**SOLICITATION AMENDMENT  
MODIFICATION DE L'INVITATION**

<b>Title - Sujet</b> Multi-Cal Rifle System	
<b>Solicitation No. - N° de l'invitation</b> W8476-196090/B	<b>Amendment No. - N° modif.</b> 010
<b>Client Reference No. - N° de référence du client</b> W8476-196090	<b>Date</b> 2020-10-13
<b>GETS Reference No. - N° de référence de SEAG</b> PW-\$\$BM-030-27872	
<b>File No. - N° de dossier</b> 030bm.W8476-196090	<b>CCC No./N° CCC - FMS No./N° VME</b>
<b>Solicitation Closes - L'invitation prend fin</b> <b>at - à 02:00 PM</b> <b>on - le 2020-10-30</b>	
<b>Time Zone</b> <b>Fuseau horaire</b> Eastern Daylight Saving Time EDT	
<b>F.O.B. - F.A.B.</b> <b>Plant-Usine:</b> <input checked="" type="checkbox"/> <b>Destination:</b> <input type="checkbox"/> <b>Other-Autre:</b> <input type="checkbox"/>	
<b>Address Enquiries to: - Adresser toutes questions à:</b> Mosher, Jeff	<b>Buyer Id - Id de l'acheteur</b> 030bm
<b>Telephone No. - N° de téléphone</b> (819) 420-1748 ( )	<b>FAX No. - N° de FAX</b> ( ) -

Amendment 010 is issued for the following reasons:

- (1) Publish Bidders' Questions and Answers;
- (2) Amend the Request for Proposal (RFP); and
- (3) Publish Attachment 1 to Annex "C" – MCSW

# Attachment 1 to Annex C

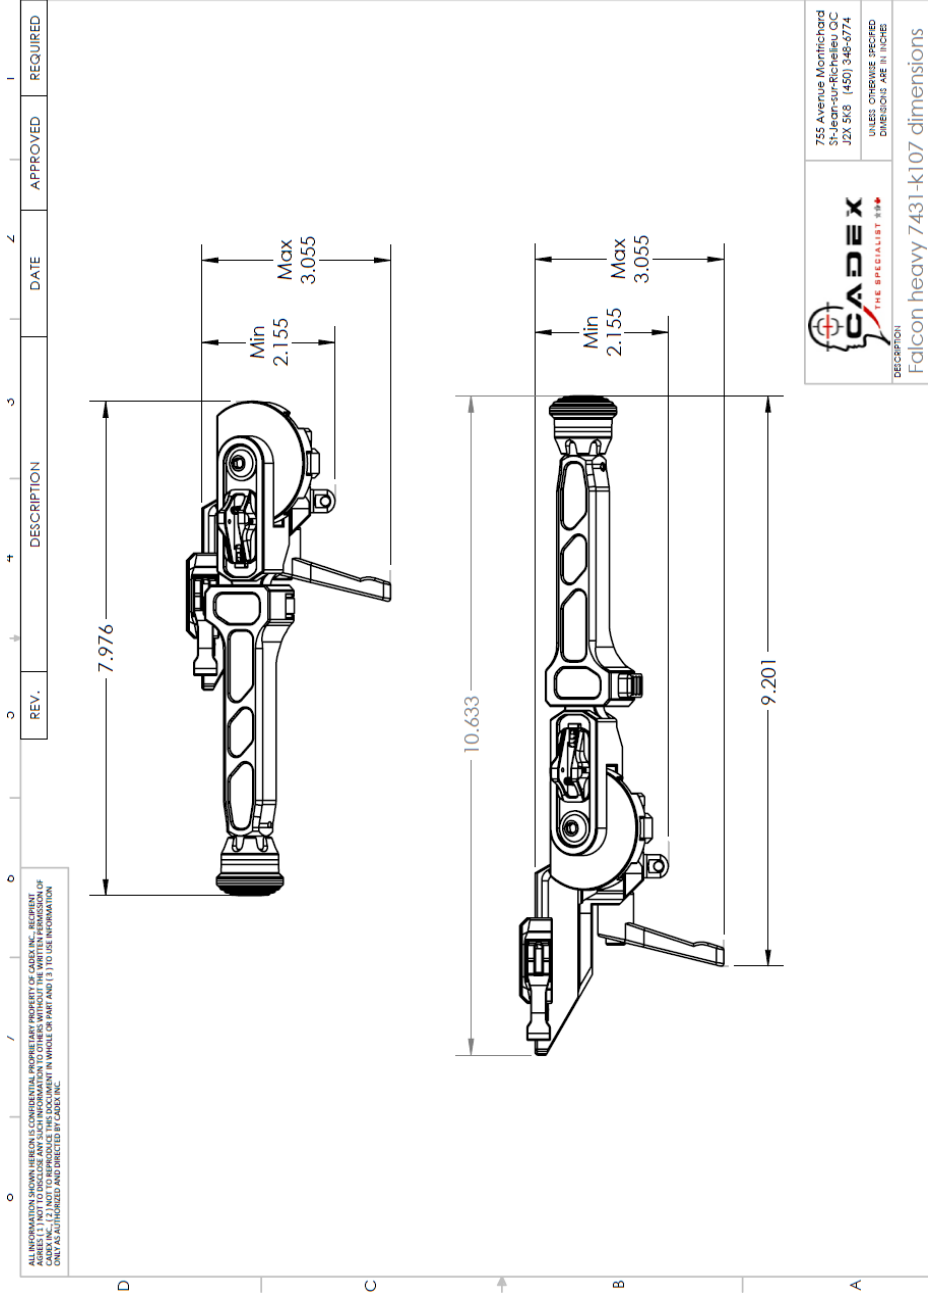
In section 3.2.2 of Annex C "Transit Case must store all MCSW system [...]", could additional information be provided in terms of model and sizing for each GFE item (Scope/Bipod/Cotton Swab/Optical Cleaning Kit/History Book), as this may impact the transit case model and pricing to be included in our proposal? Also, can a bolt assembly and magazine be installed on the Rifle while stored in the transit case or they need to be separate from the rifle?

Attachment 1 to Annex C has been provided and includes additional information on GFE items.

3.2.2 The Transit Case **must** store the entire MCSW System. See Figure 1 for a list of items included in the MCSW System. See Attachment 1 for additional information on GFE Items.
